**RESPONSE TO ASSESSMENT MANAGER'S INFORMATION REQUEST
DEVELOPMENT ASSESSMENT RULES 2017 PART 3 S13
DEVELOPMENT APPLICATION FOR A DEVELOPMENT PERMIT
FOR RECONFIGURING A LOT (1 LOT INTO 2)
AT 3 SEASPRAY DRIVE, AGNES WATER
(LOT 28 RP803327)**

**DA/12/2023 - RECONFIGURING A LOT - IMPACT
1 INTO 2
3 SEASPRAY DRIVE, AGNES WATER QLD 4677
LOT 28 RP 803327**

Figure 1: Example of Proposed Envelope

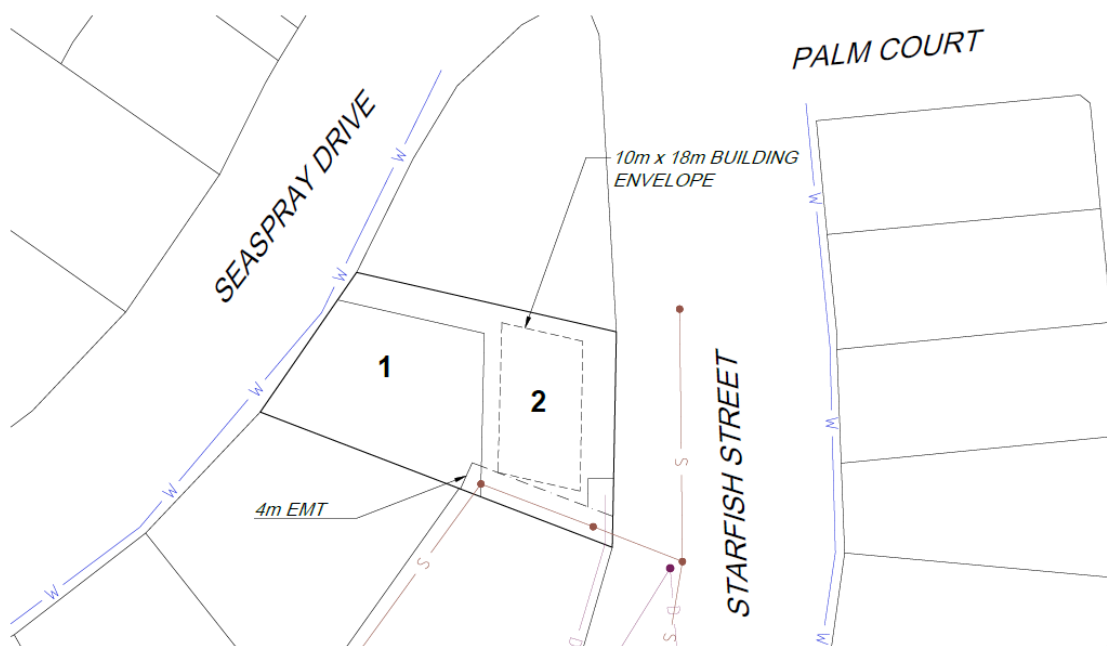
- a. Provide revised plans that demonstrate a building envelope for the rear allotment (Proposed Lot 2), with a minimum dimension of 15m x 20m, exclusive of the area for proposed stormwater and sewer easements, and compliant with setback requirements of Queensland Development Code MP1.2.

The proposed subdivision can facilitate appropriate low-scale residential development on each proposed allotment. To provide an example of a sufficient building envelope that could occur on proposed Lot 2, the side boundaries have been maintained at 2m while the frontage has a reduced setback of 4m. This would allow sufficient space for a modest single storey or larger 2-storey Dwelling House with ancillary structures and outdoor space. This envelope example has also considered the provision of a future easement over the existing network which can be viewed below in **Figure 1**.

As the application only seeks a Reconfiguration of a Lot, and the future house plans have not been finalised for Lot 2, the Applicant would like to retain flexibility on potential frontage relaxations to Starfish Street and not include a building envelope at this stage. It is further noted that a future Dwelling House may require an assessable Material Change of Use application on both allotments due to the overlays. As such, Council can appropriately assess the necessary design requirements at this stage.
